**PLANNING COMMISSION TENTATIVE AGENDA  
7:00 PM**

A. Bethel Assemblies of God Church Wireless Communication Tower CUP  
Consider request for a conditional use permit (CUP) for a wireless communications tower on the Bethel Assemblies of God Church property.  
LOCATION: 14201 Cedar Avenue  
PETITIONER: Buell Consulting, on behalf of Cellco Partnership (d/b/a Verizon Wireless)

<b>Description:</b> Bethel Assemblies of God Church Wireless Communication Tower CUP		
<b>Staff Contact:</b> Sydnee Stroeing, Associate Planner		<b>Department / Division:</b> Community Development Department
<b>Applicant:</b> Buell Consulting, on behalf of Cellco Partnership		<b>Project Number:</b> PC25-02-C
<b>Applicant Date:</b> 2/3/2025	<b>60 Days:</b> 4/4/2025	<b>120 Days:</b> 6/3/2025

SUBJECT: Bethel Assemblies Church Tower CUP plans dated 1/13/2025

T-1

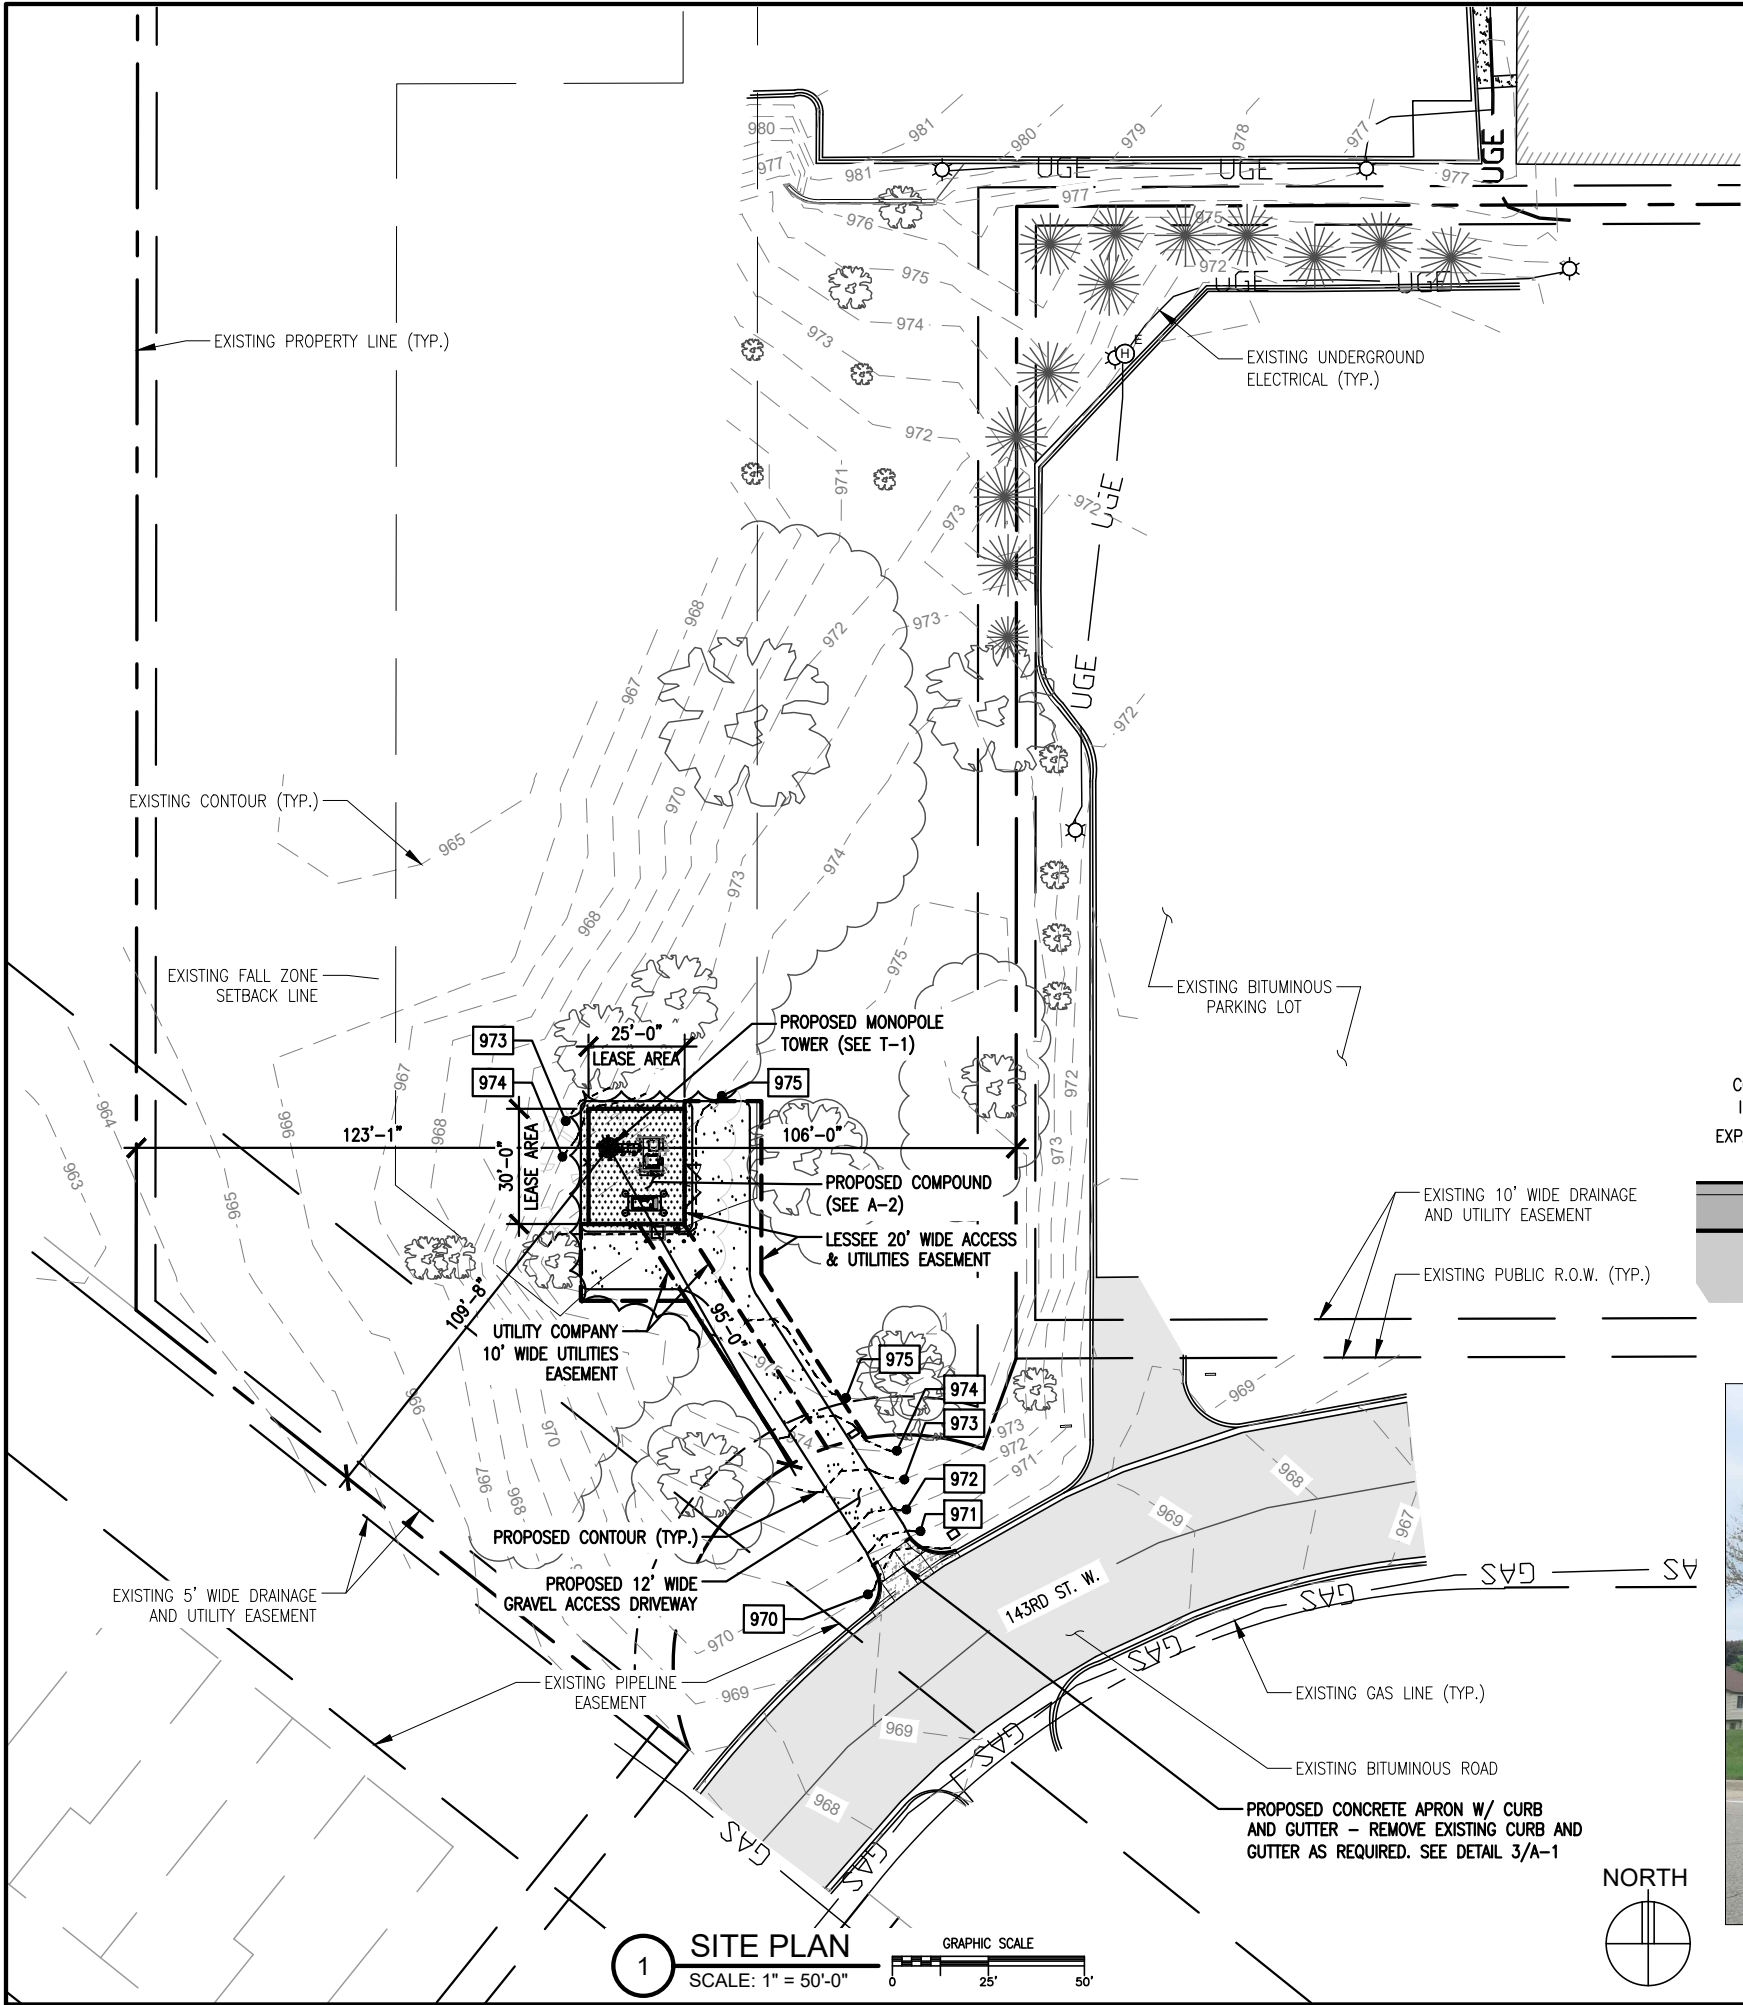
The tower will be designed with an engineered "breakpoint" technology which will ensure that if the tower fails and collapses, it will fall upon itself. The setbacks for a tower are based on the breakpoint height. With the breakpoint, the minimum setback from property lines is 64.5'. The site plan shows the proposed tower 95' from the nearest property line. All setbacks to property lines are met. There is also a setback requirement to structures on neighboring properties. The minimum setback for the tower from a structure on a neighboring property is 86' (due to the engineered breakpoint). The nearest structure on a neighboring property is 153' from the proposed tower. All structure setbacks are also met.

A-1

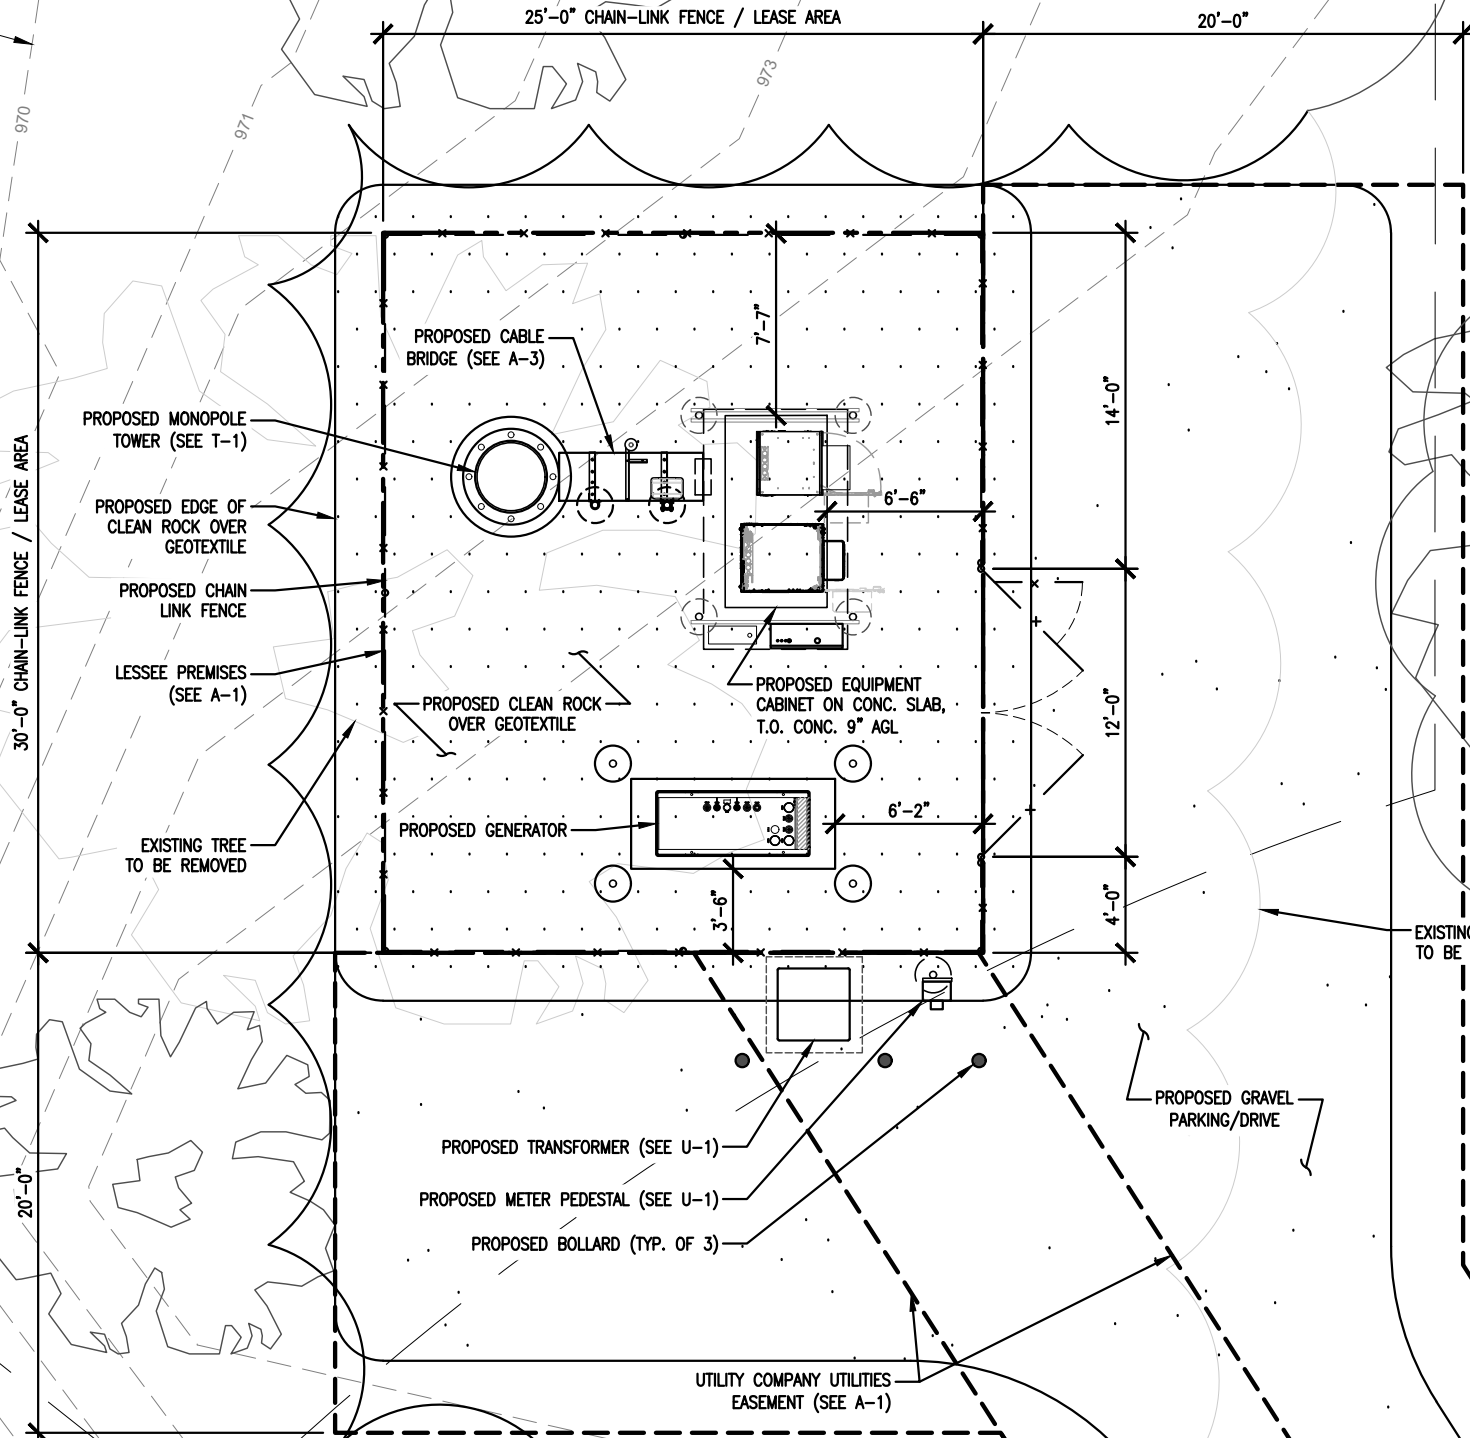
Access to the tower and associated equipment is shown to be via a 12' wide path off 143rd St W. The driveway to the tower will be required to be paved per City Code. Additionally, the Assistant City Engineer's memo provides a condition that a sidewalk shall be installed from the existing driveway to the east of the proposed access to the west property line. The City utilizes its authority under ordinance requirements and guiding plan documents to require sidewalk gaps be completed by private development as development (and redevelopment) work occurs where current gaps exist.

10. Show locations of proposed lighting fixtures for parking lots and site.
11. Final site plan to be approved by the City Engineer
12. The City will require the new driveway entrance to be a Non-Residential Driveway (Concrete Entrance). See City Detail plate STR-5.
  - The detail on sheet A-1 should be changed to reflect City Plate STR-5.
13. The City requires that sidewalk is extended from the existing driveway to the east of the proposed access to the west property line.
  - The sidewalk shall be 6' in width and built per city detail STR-35
  - STR-35 shall be shown on the plans
  - Proposed handholes shall be located outside of the sidewalk.
14. All driveways must be paved surface (concrete or asphalt).
  - The plans currently show a gravel driveway access.
